**GEYSERS POWER COMPANY, LLC**  
**CONSOLIDATED PETITION FOR A STAFF APPROVED MODIFICATIONS**

**GPC Quicksilver Power Plant**  
**GPC Socrates Power Plant**  
**GPC Grant Power Plant**  
**Geysers Unit 16 Docket: 79-AFC-OSC**  
**Geysers Unit 18 Docket: 79-AFC-OJC**  
**Geysers Unit 20 Docket: 82-AFC-01C**

CALPINE CORPORATION		JOB NUMBER	144890
COOLING TOWER		REV	△
FIELDWIDE UPGRADES		DRAWING NUMBER	16M1-1
UNIT 16 SITE PLAN			
FIRE PREVENTION UPGRADES

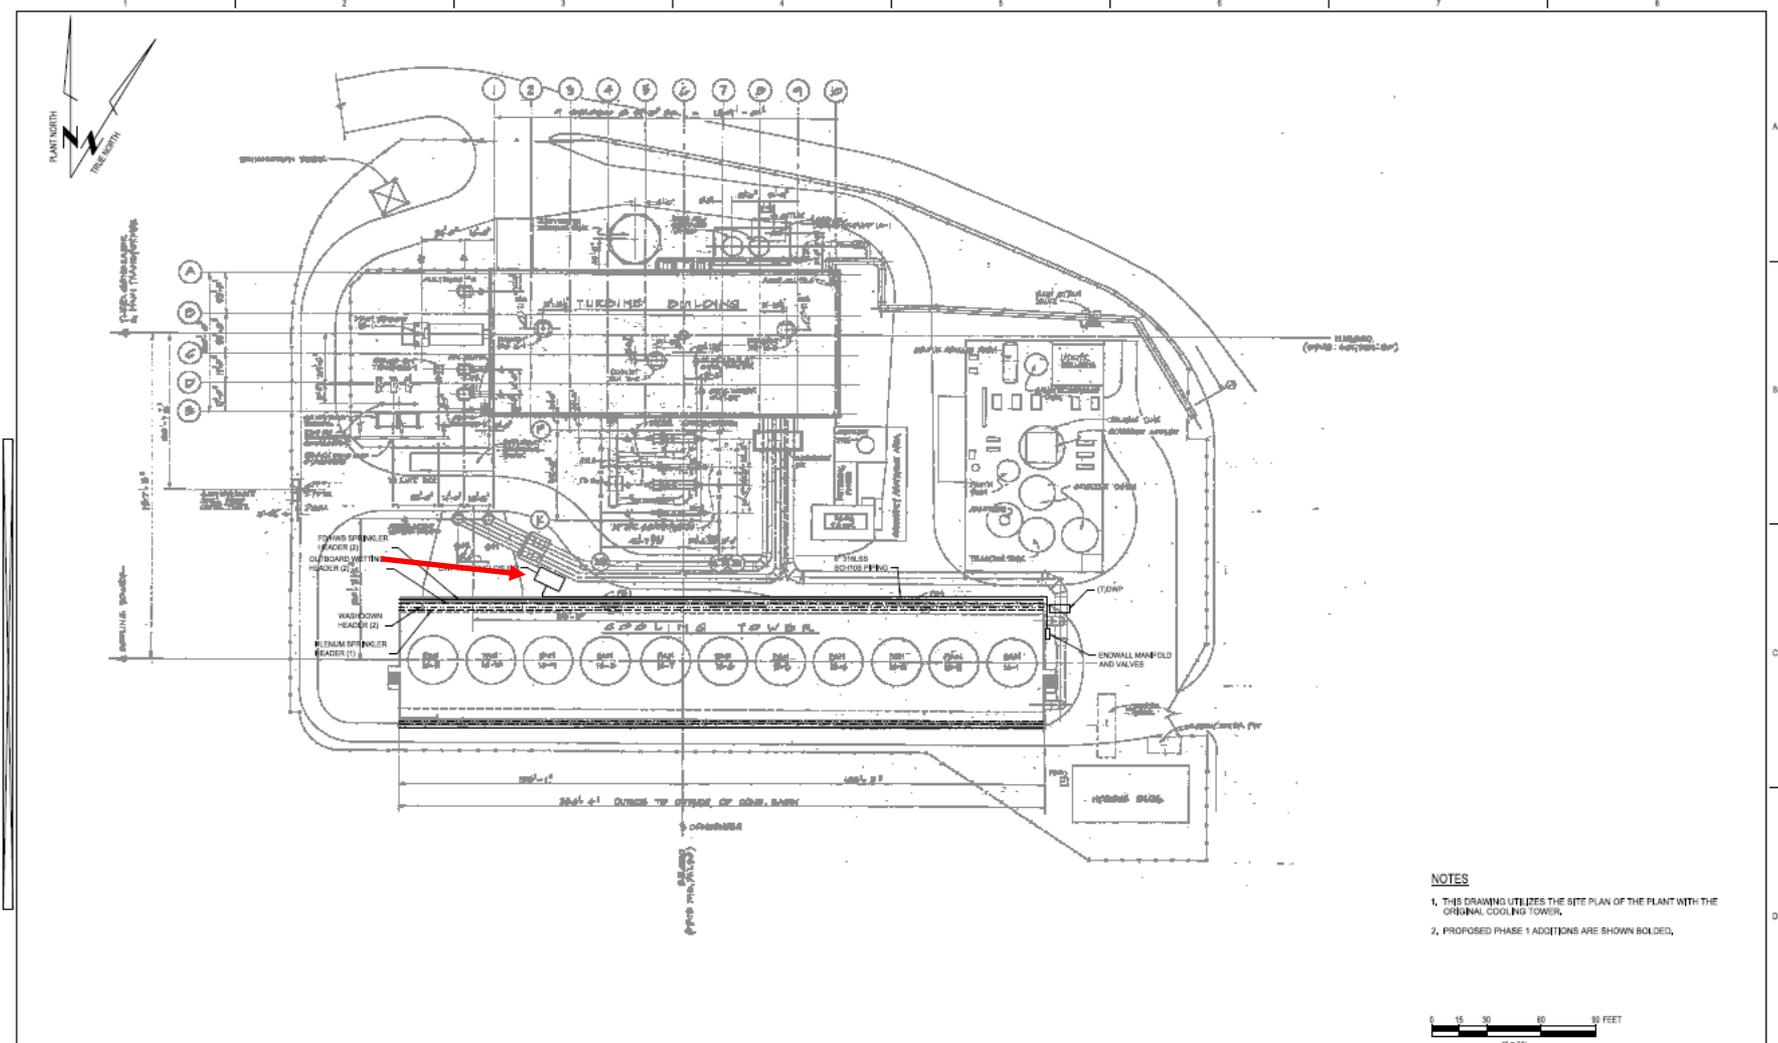
- NOTES**
1. THIS DRAWING UTILIZES THE SITE PLAN OF THE PLANT WITH THE ORIGINAL COOLING TOWER.
  2. PROPOSED PHASE 1 ADDITIONS ARE SHOWN BOLDDED.

New DWP

CALPINE CORPORATION	JOB NUMBER	REV
		COOLING TOWER FIELDSIDE UPGRADES	144892	△
UNIT 18 SITE PLAN		DRAWING NUMBER		
FIRE PREVENTION UPGRADES		18M1-1

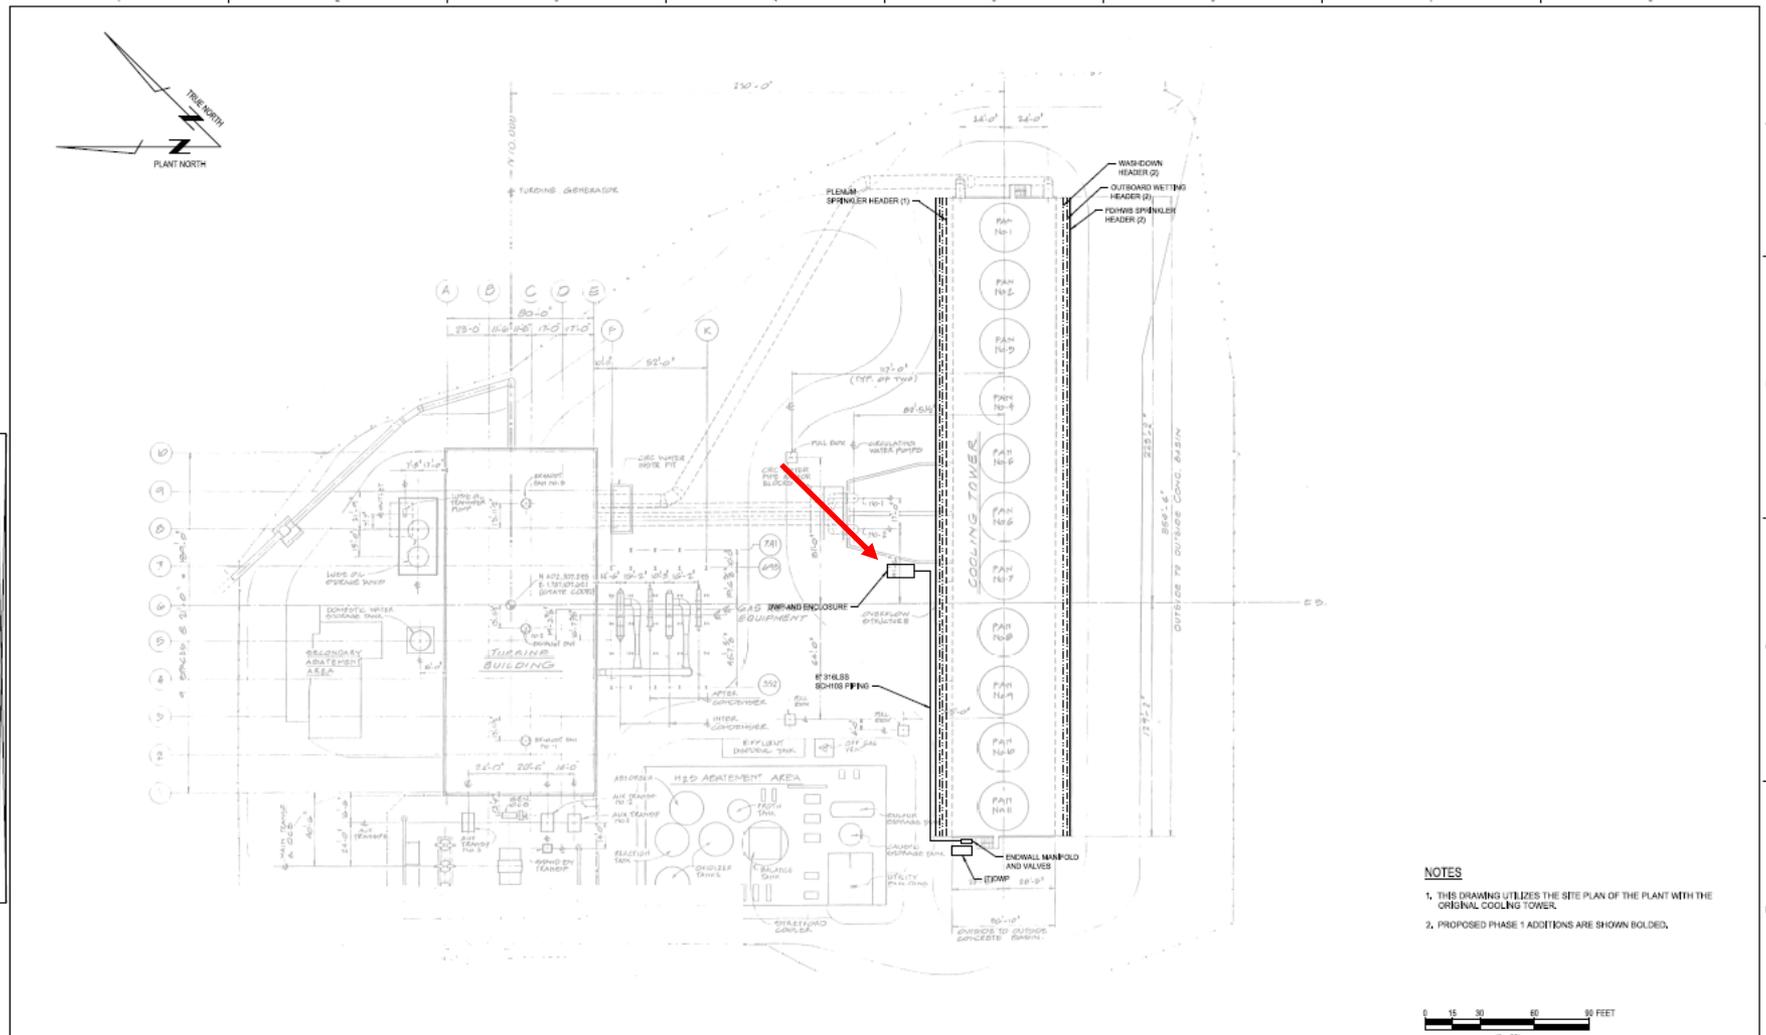
- NOTES**
1. THIS DRAWING UTILIZES THE SITE PLAN OF THE PLANT WITH THE ORIGINAL COOLING TOWER.
  2. PROPOSED PHASE 1 ADDITIONS ARE SHOWN BOLD.

New DWP

CALPINE CORPORATION	JOB NUMBER	REV
COOLING TOWER FIELDWIDE UPGRADES	144890	△
UNIT 20 SITE PLAN FIRE PREVENTION UPGRADES	DRAWING NUMBER	
	20M1-1

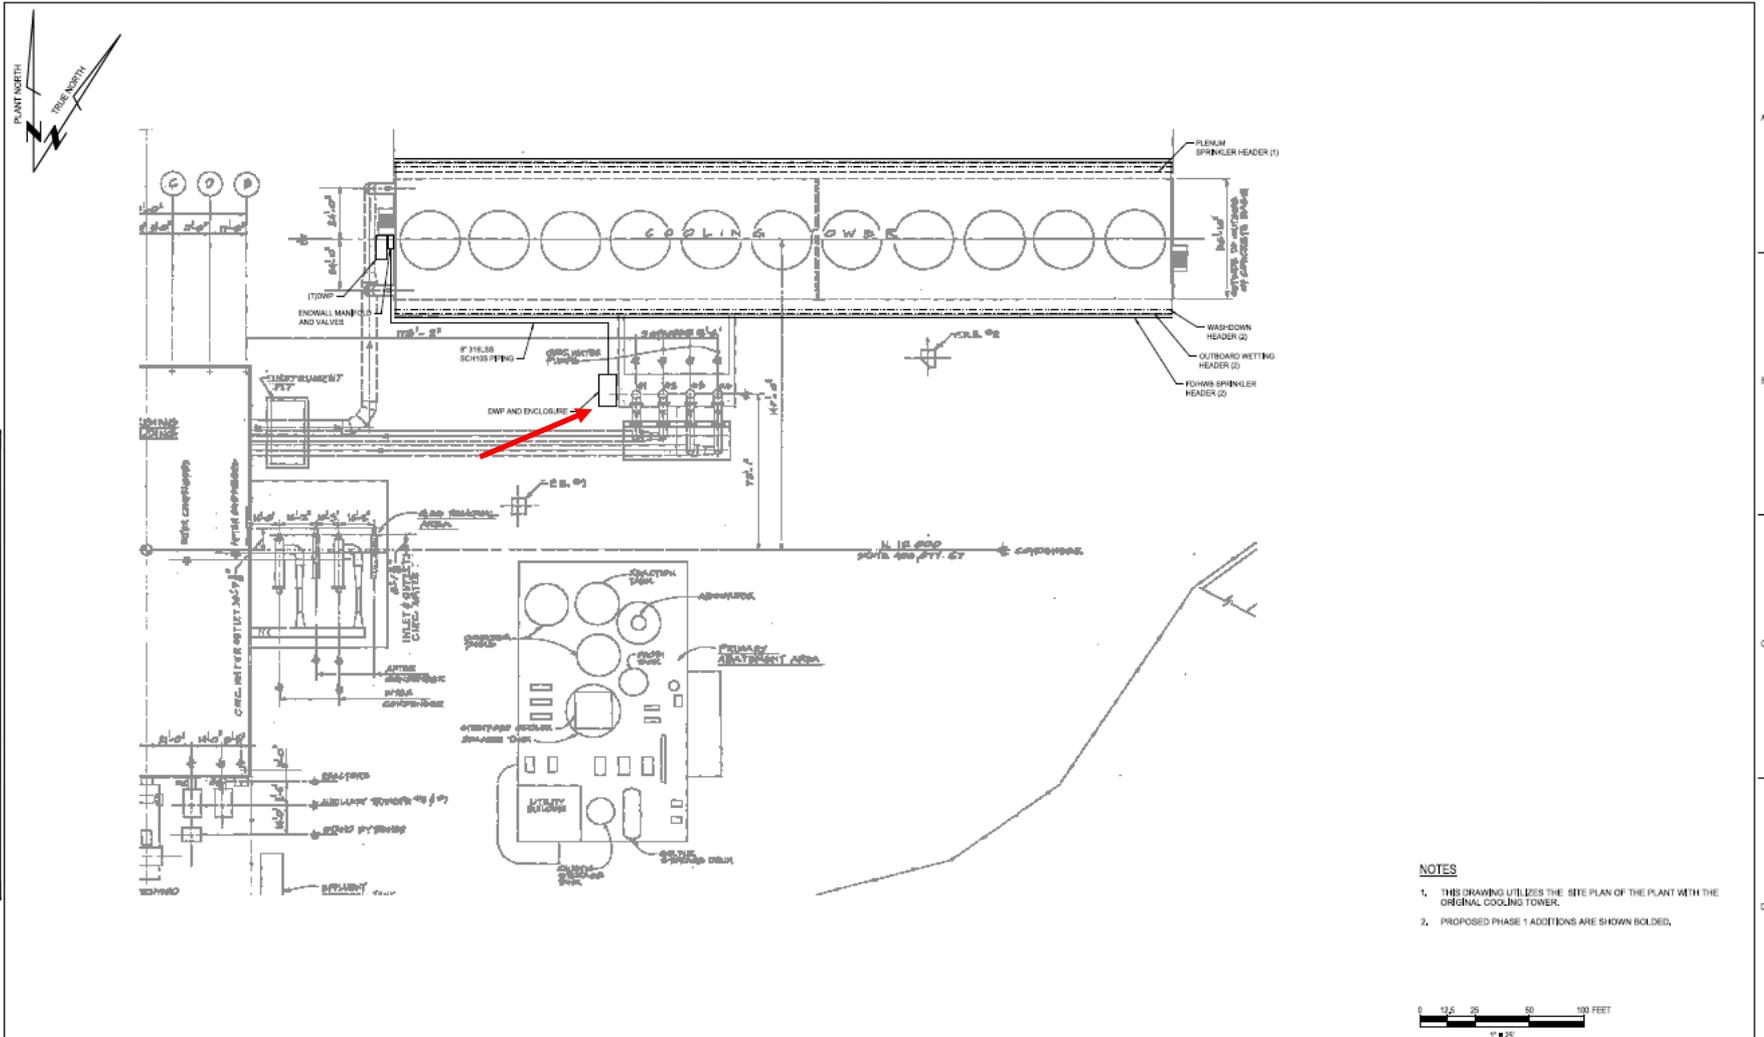
- NOTES**
1. THIS DRAWING UTILIZES THE SITE PLAN OF THE PLANT WITH THE ORIGINAL COOLING TOWER.
  2. PROPOSED PHASE 1 ADDITIONS ARE SHOWN BOLDED.

New DWP
